**RE: Minor Subdivision Plan – Completeness Review #1
Christopher Spagnoli
402 Sixth Avenue (Block 39, Lot 76)
Borough of Spring Lake Heights, Monmouth County, New Jersey
EPE Project Number: SLHPB-2020-02**

**Re: Spagnoli
Minor Subdivision
402 Sixth Avenue
Block 39, Lot 76
Our File: SLHPB 20-01**

**Re: Spagnoli
Minor Subdivision
402 Sixth Avenue
Block 39, Lot 76
Second Planning Review
Our File: SLHPB 20-01**

Conceptual
Plan

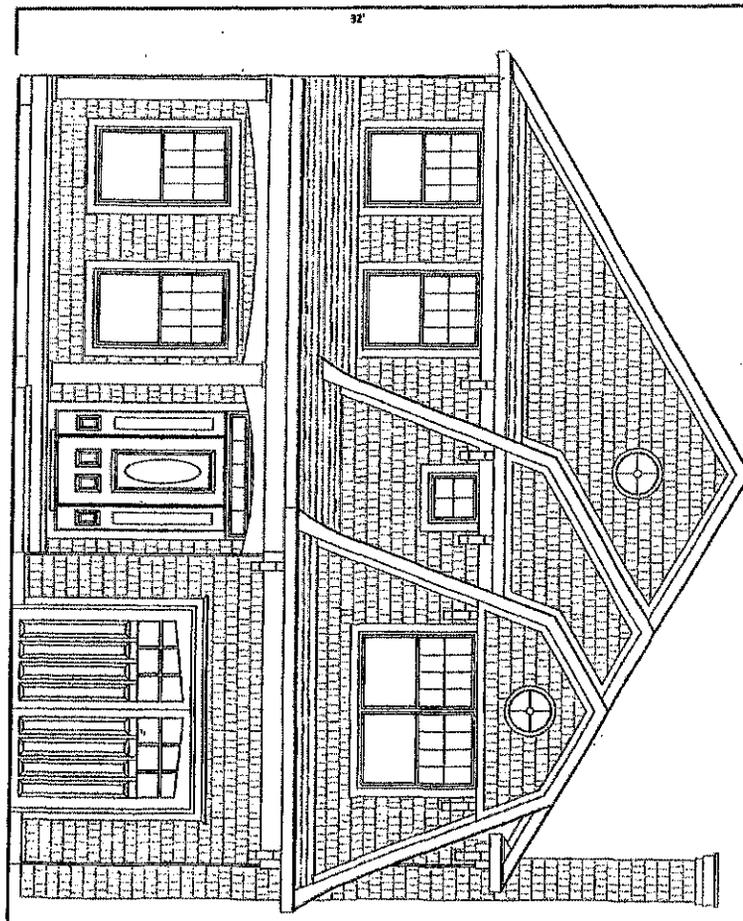
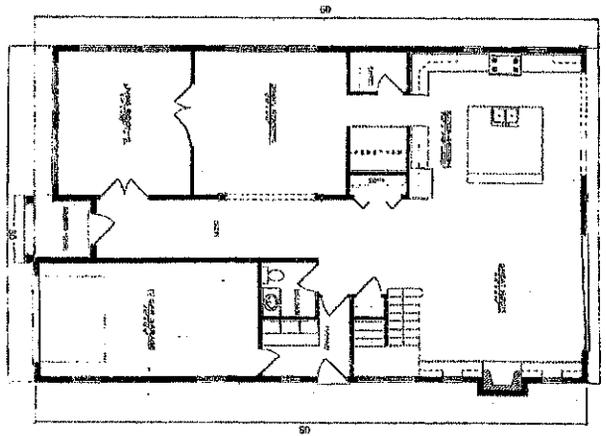
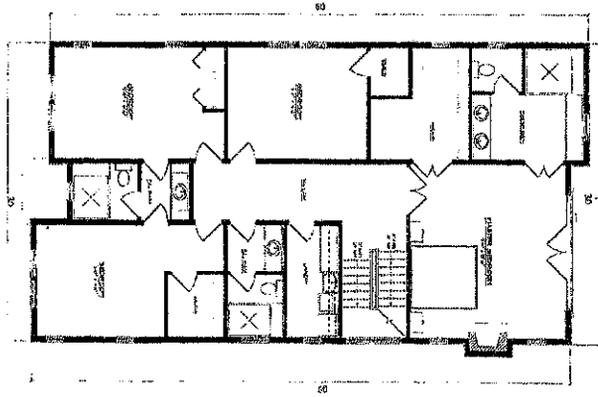
4. The ground floor elevation and first floor elevation of the proposed 2 story dwelling should be confirmed, and the site plan should be revised to reflect the elevations, as necessary.
5. ~~The side yard setback of proposed lot 76.01 should be confirmed. The zoning table indicated 26.5 ft., whereas the site plan indicated 26.1 ft.~~ ***This has been addressed.***
6. ***The applicant is proposing to remove the existing steps along the northern side of the existing structure on proposed lot 76.01, as they would encroach on the proposed lot line. The applicant should indicate if the existing door is proposed to be closed up, or if new stairs are proposed to provide safe egress from the doorway.***
